DATE: September 5, 2018
TO: Joseph Laydon
COMPANY: Town of Grafton
FROM: Bob Egan
RE: Dana Transport

PROPOSED SITE PLAN
FOR
EQUIPMENT CARE CENTER OF GRAFTON
IN
NORTH GRAFTON, MASSACHUSETTS

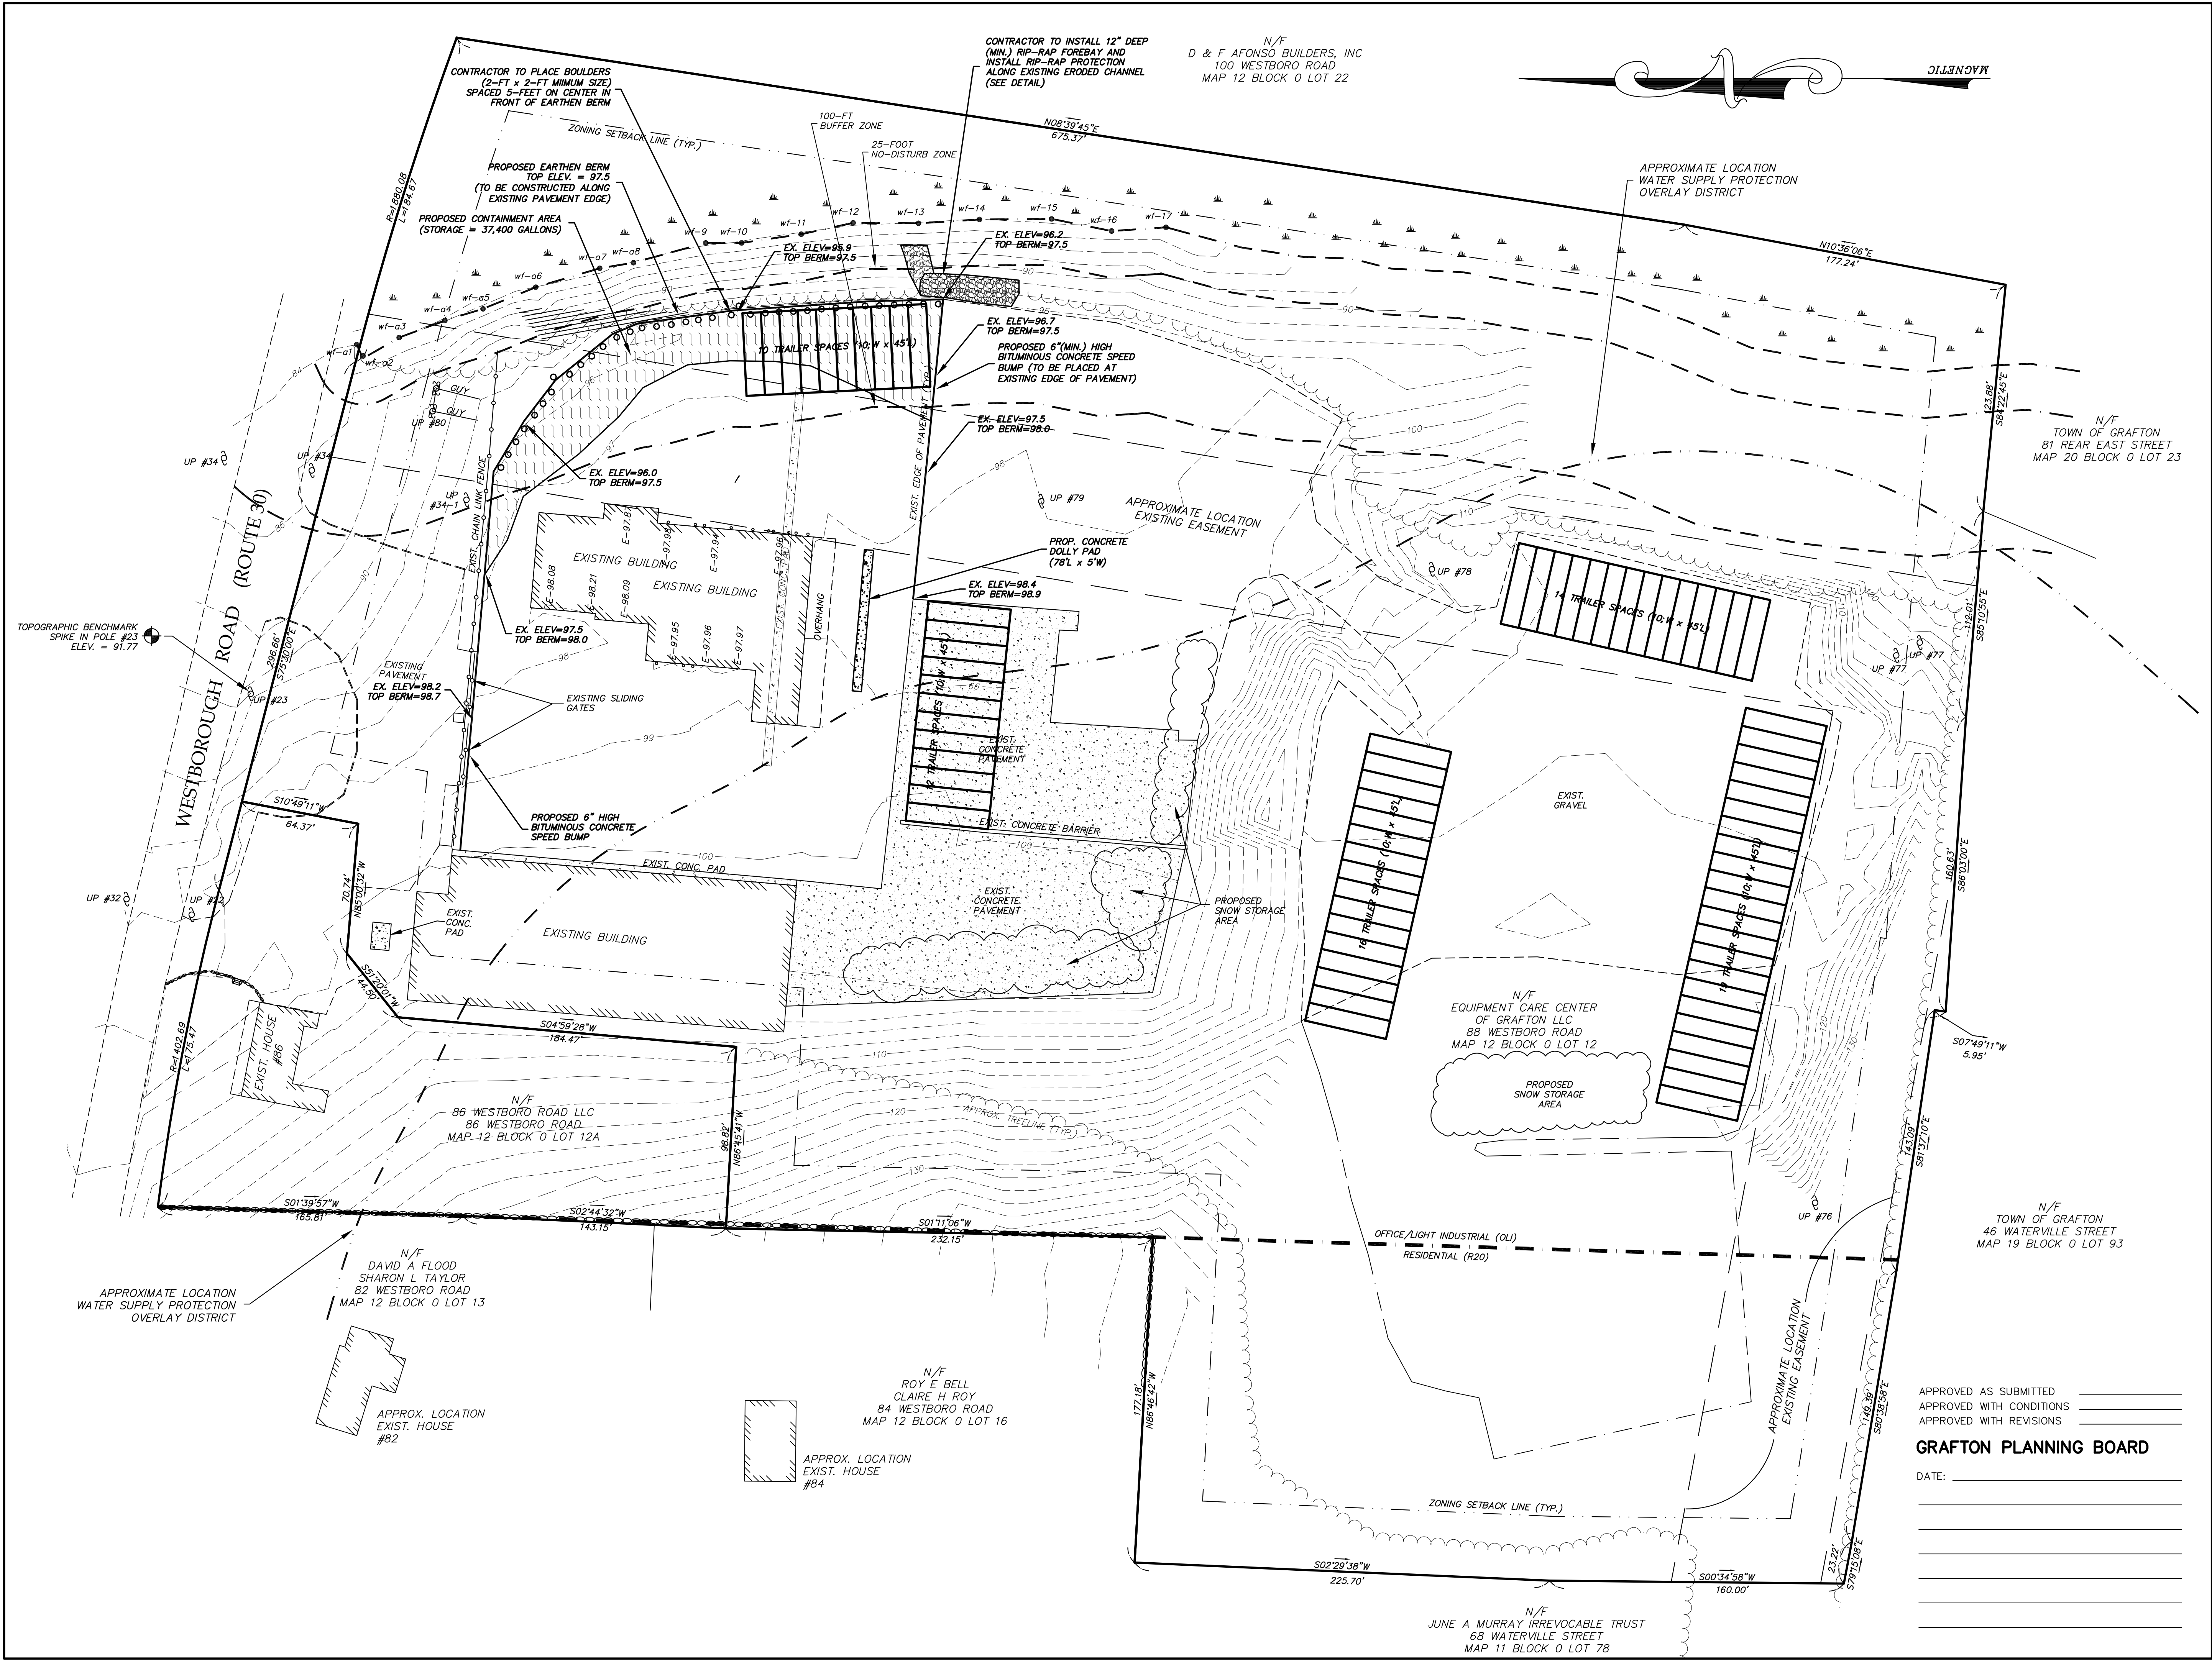
My rationale for changing the wood guard rail to boulders was that the drivers will pay attention to the boulders. They will hear the back of the trailer hitting a boulder much louder than a wood guard rail, and I need the cost savings to regrade and pave the back of the wash building.
